6.10m TOWNS
WILLOW
MODELS
TH-37 TO TH-42

BASEMENT PLAN ELEV-3

BARLASSINA CONSTRUCTION
CAMBRIDGE, ONTARIO

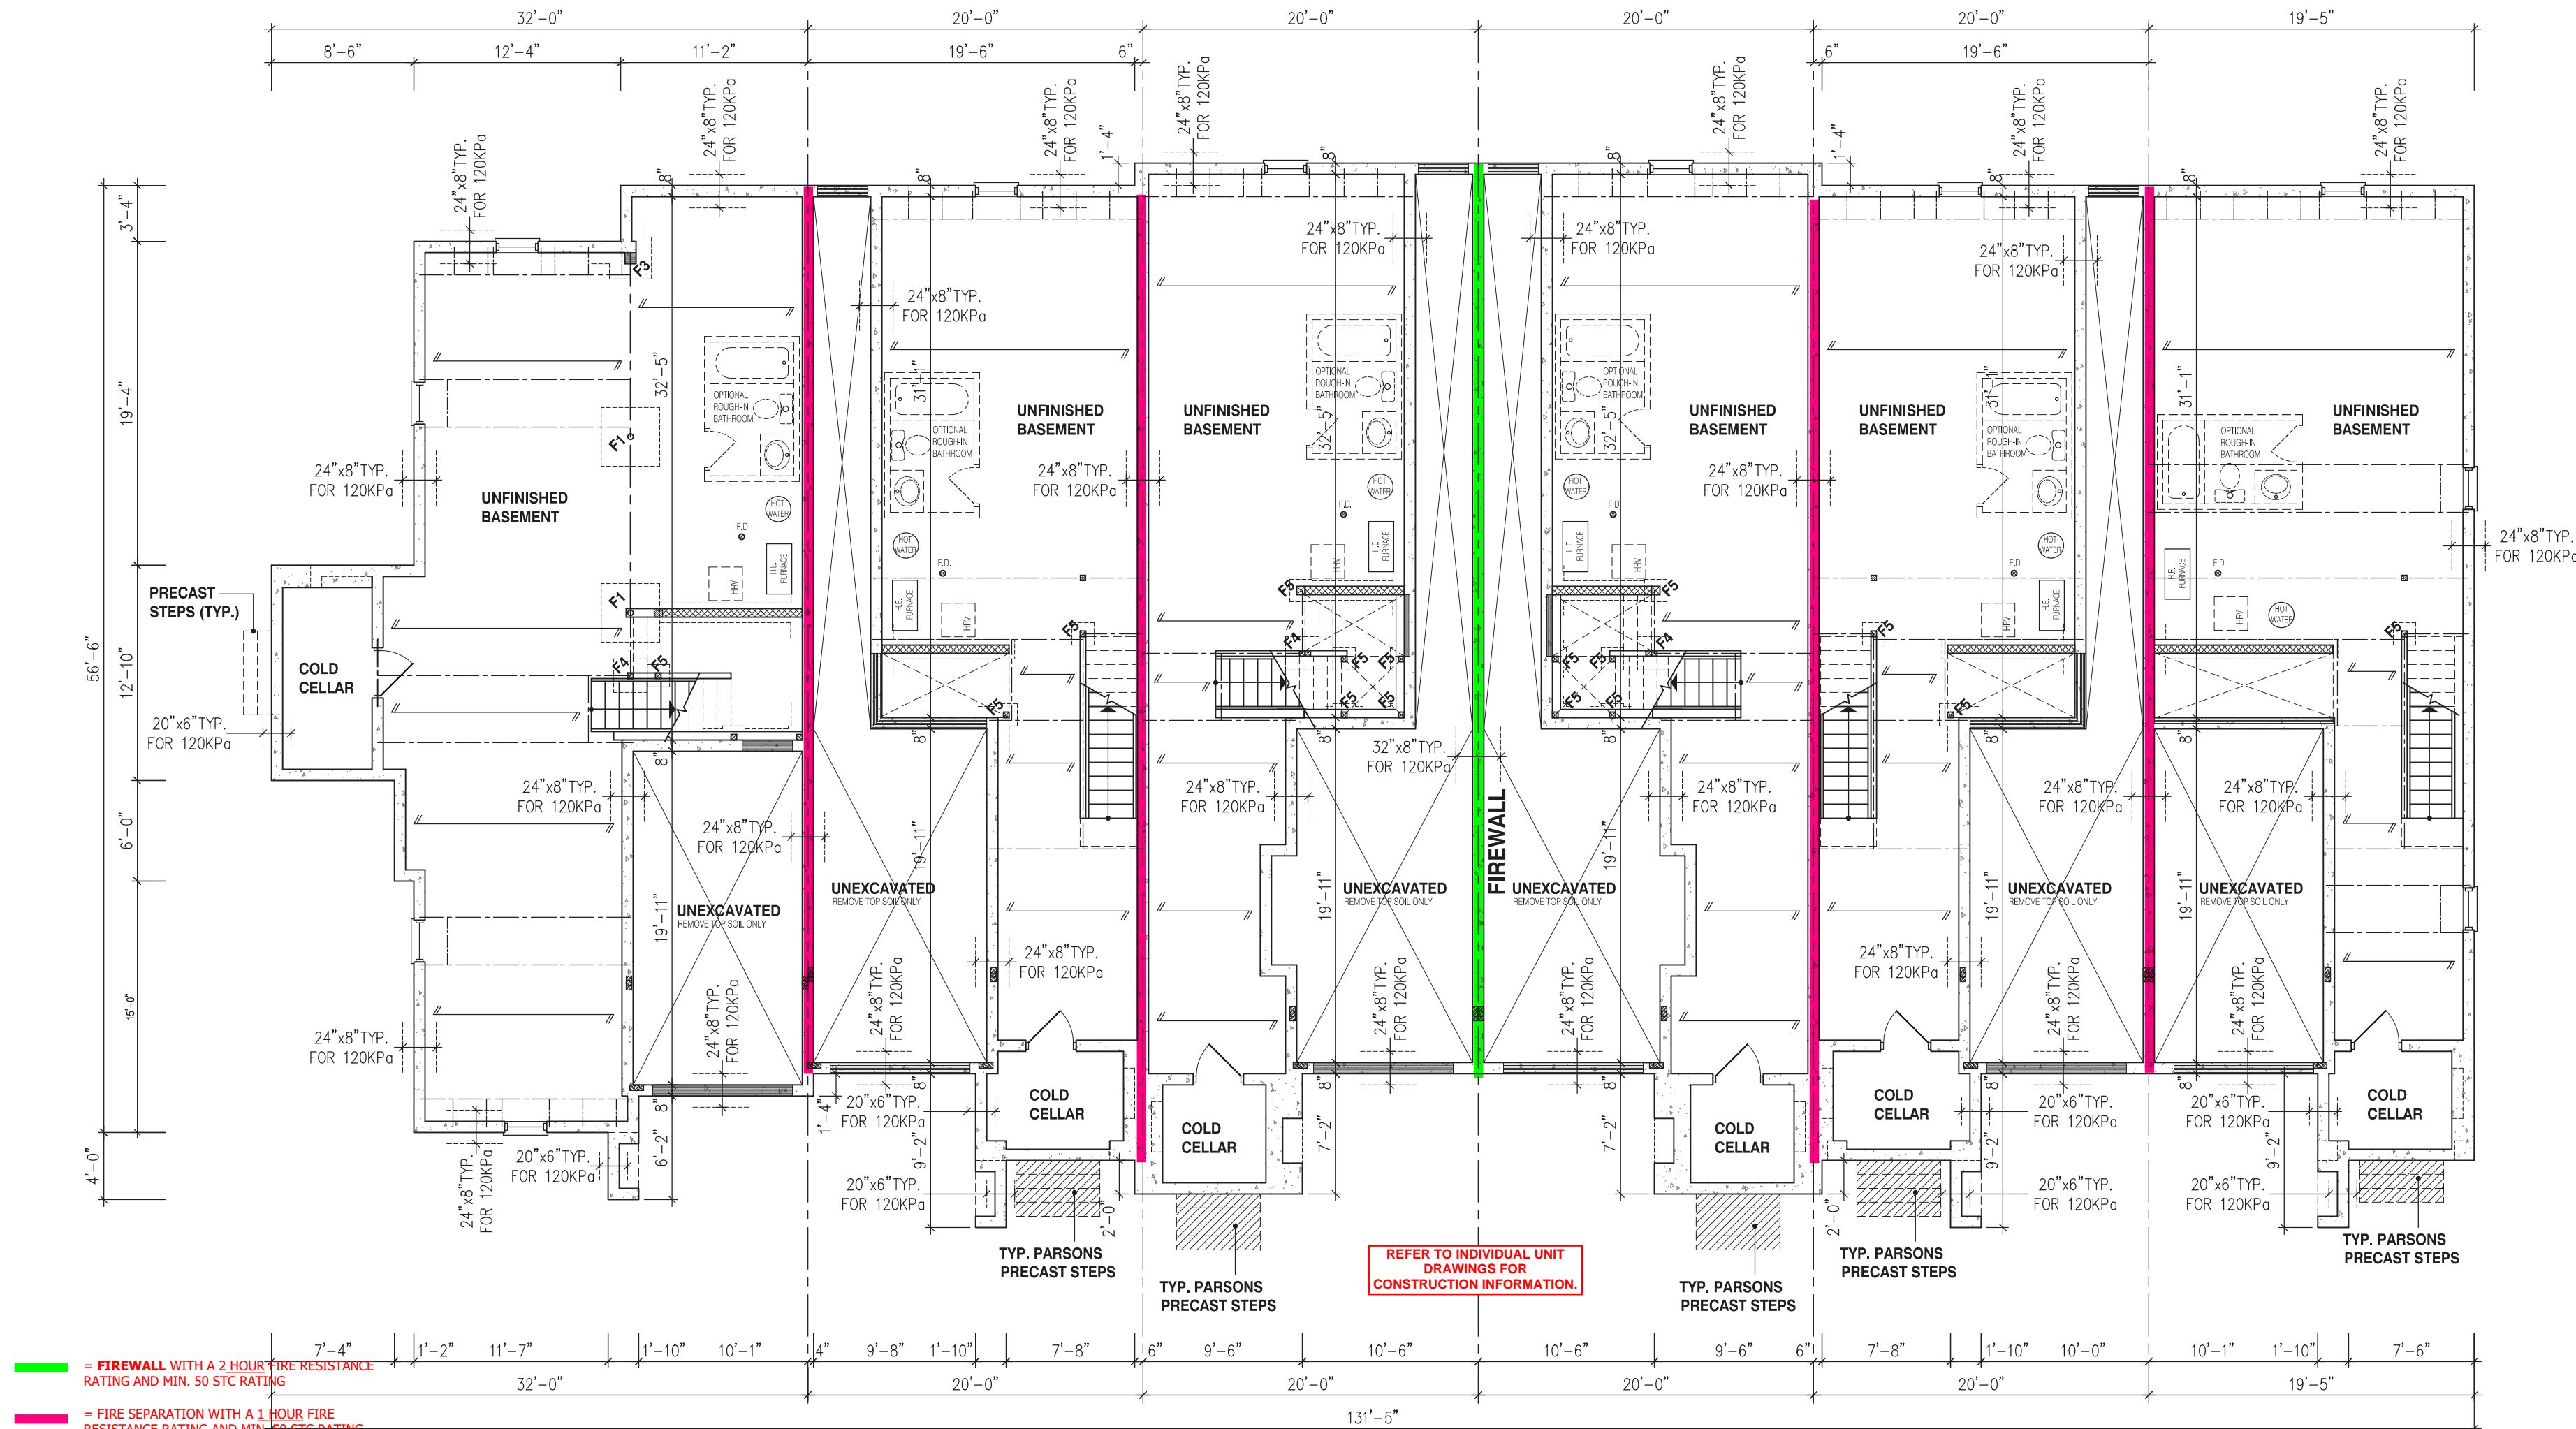
NON-LOADBEARING INTERIOR
WALLS ARE NOT TO BE FRAMED IN
UNFINISHED BASEMENTS

REINFORCING REQUIRED IN FOUNDATION WALL OR PORCH SLAB SHALL BE REVIEWED PRIOR TO POURING CONCRETE (see inspector)

SINGLES - WEeping TILE REQ'D AROUND EACH UNIT CONNECTED TO SEPARATE SUMP/DRYWELLS
TOWNHOUSES - WEeping TILE MAY CIRCLE ENTIRE BUILDING AND BE CONNECTED TO 1 SUMP/DRYWELL

A SEPARATE PERMIT IS REQUIRED FOR THE FINISHING OF ALL ROUGH-IN PLUMBING FIXTURES
